**SUBJECT:** NuScale Power, LLC Submittal of Changes to Figure B 3.2.2-1 of the Technical Specification Bases

Enclosure: "Changes to Technical Specification Bases Figure B 3.2.2-1, Axial Offset Window"

Figure B 3.2.2-1 (page 1 of 1)  
Axial Offset Window

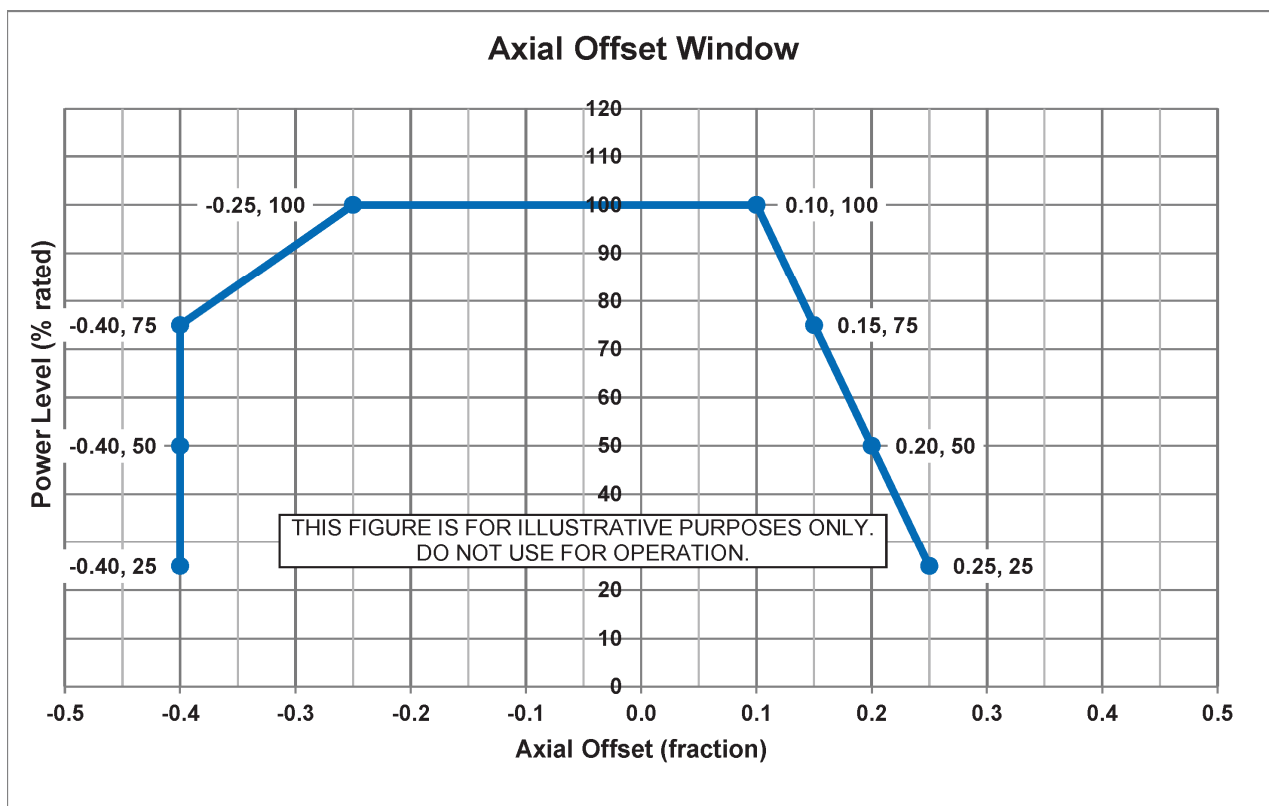
During a May 15, 2017 public phone call with Bruce Baval of the NRC staff, NuScale Power, LLC (NuScale) discussed an inconsistency between Final Safety Analysis Report (FSAR) Figure 4.3-3, Axial Offset Window, and the Technical Specification (TS) Bases Figure B 3.2.2-1, Axial Offset Window. As a result of this discussion, NuScale revised the TS Bases figure. The Enclosure to this letter provides a mark-up of the NuScale TS Bases figure incorporating the change to correct the inconsistency between the FSAR and TS Bases figures. NuScale will include these changes as part of a future revision to the NuScale Design Certification Application.
